Bulletin Number - BP3 Promenade - Bulletin 08

Project	Steamboat Base Village Redevelopment	Date	08/06/2021
Project Location	Steamboat, Colorado	Architect's Project Number	03.7835.000
Owner/Client	Alterra Mountain Company / East West Partners	File	6BL This is page 1 of 2
To	Saunders Construction Inc.	Attention	Bryan Sculthorpe
Address	86 Inverness Place North		
City	Englewood	State	CO Zip Code 80112
Delivered via:	<input type="checkbox"/> Messenger <input type="checkbox"/> Hand carried <input type="checkbox"/> Facsimile <input type="checkbox"/> Express <input type="checkbox"/> Pick-up <input type="checkbox"/> E-mail Address <input type="checkbox"/> Mail <input type="checkbox"/> UPS <input checked="" type="checkbox"/> Website Address BIM360

Description of Changes

⑤ (DE) SITE POWER PEDESTAL - 12" (2) QUAD
NO SCALE

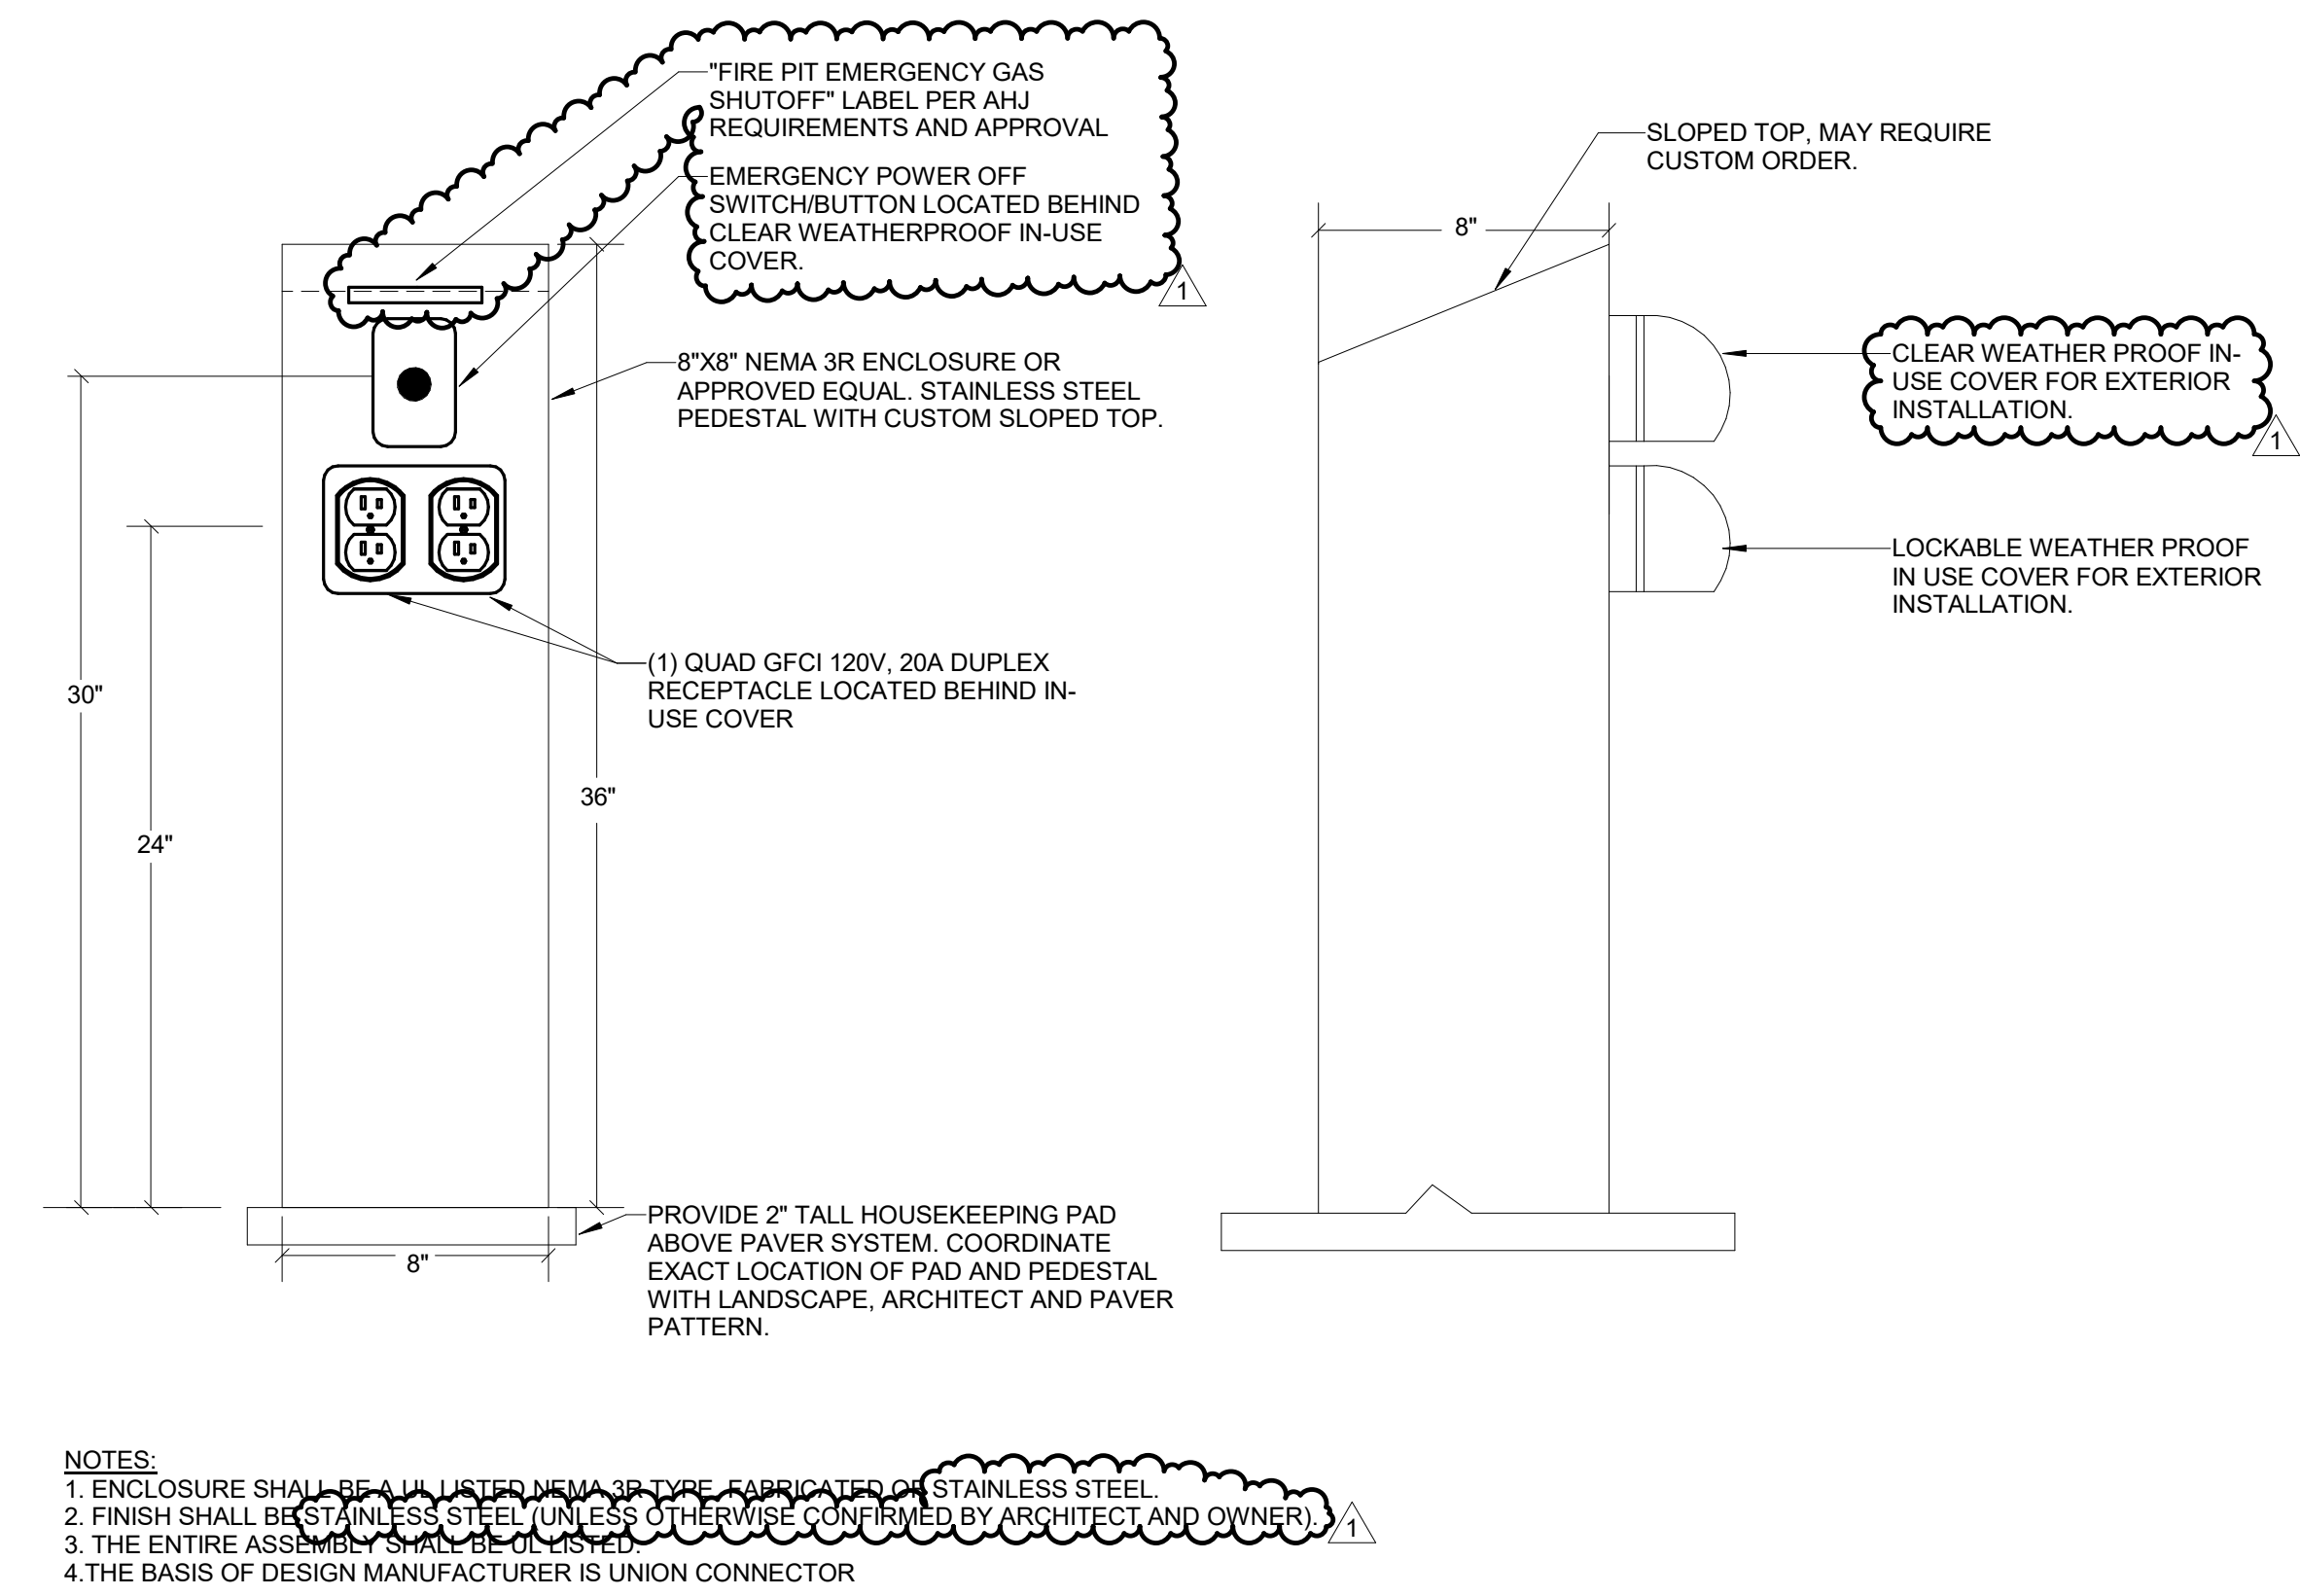
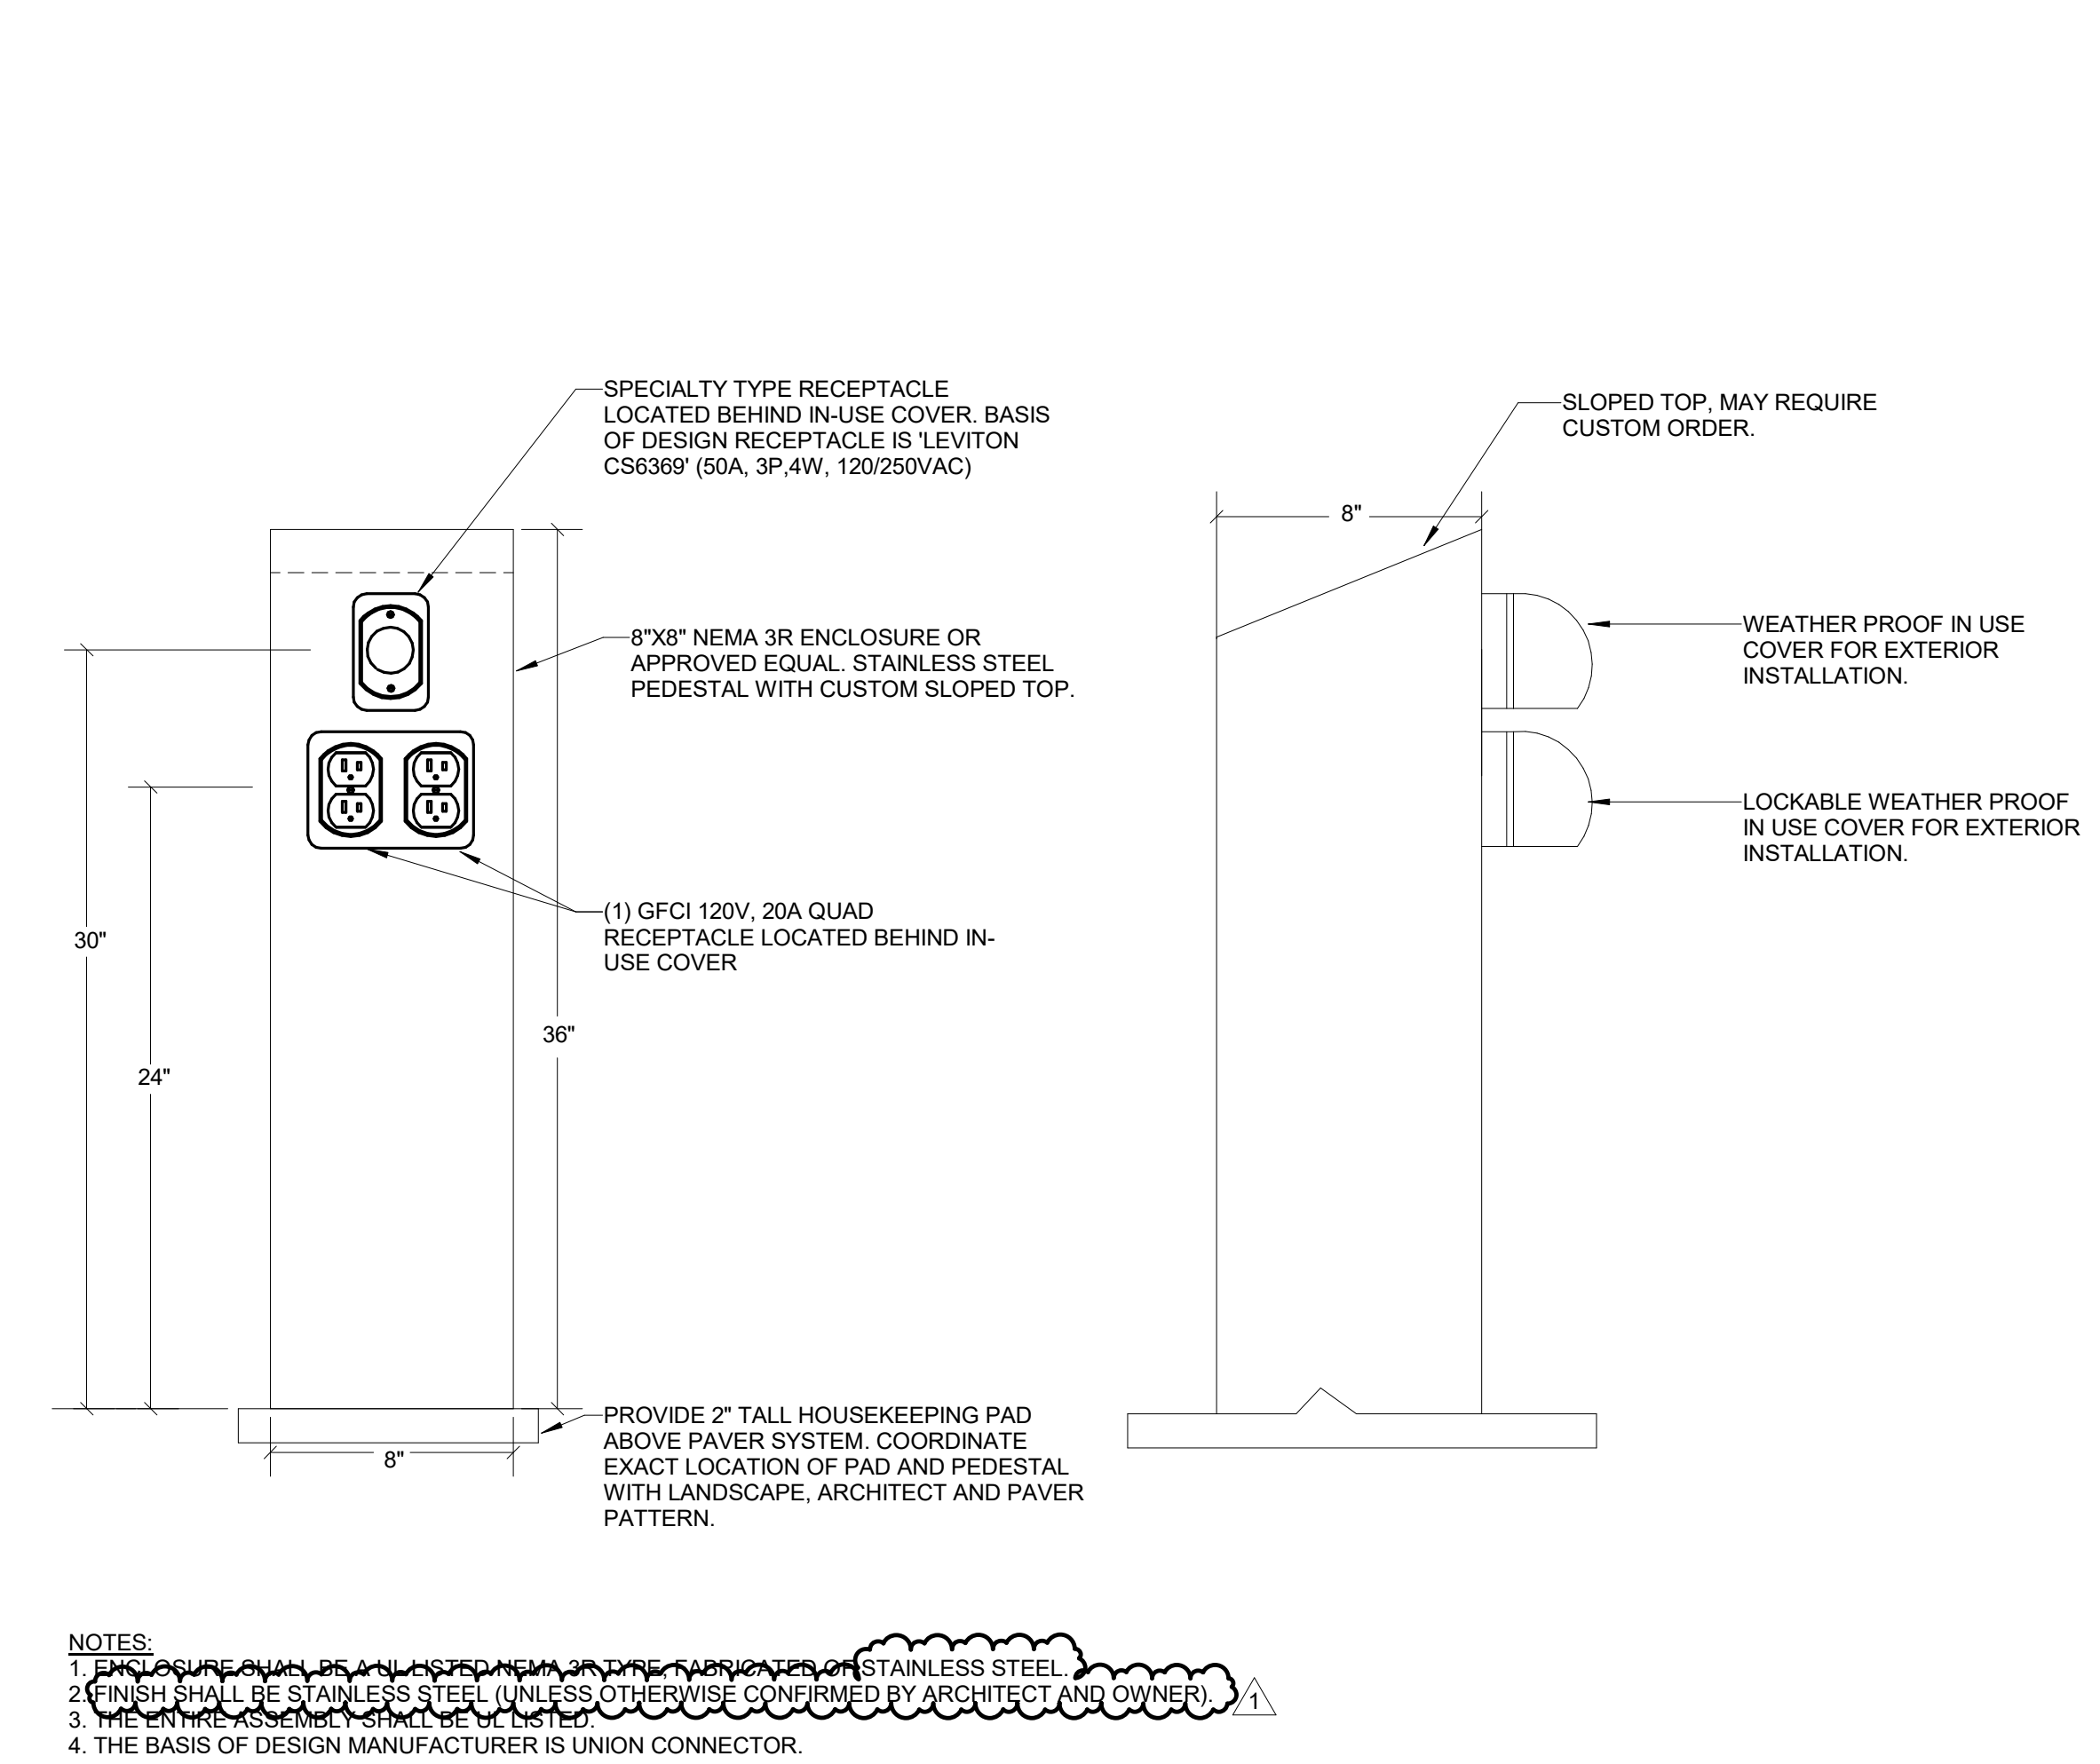
- b. Modified lighting controls matrix to align with design intent and conversations with lighting controls rep.
- 34. 1A-E8.002
 - a. Modified plaza details for added clarity to design intent of plaza pedestals and fire pit EPO buttons.
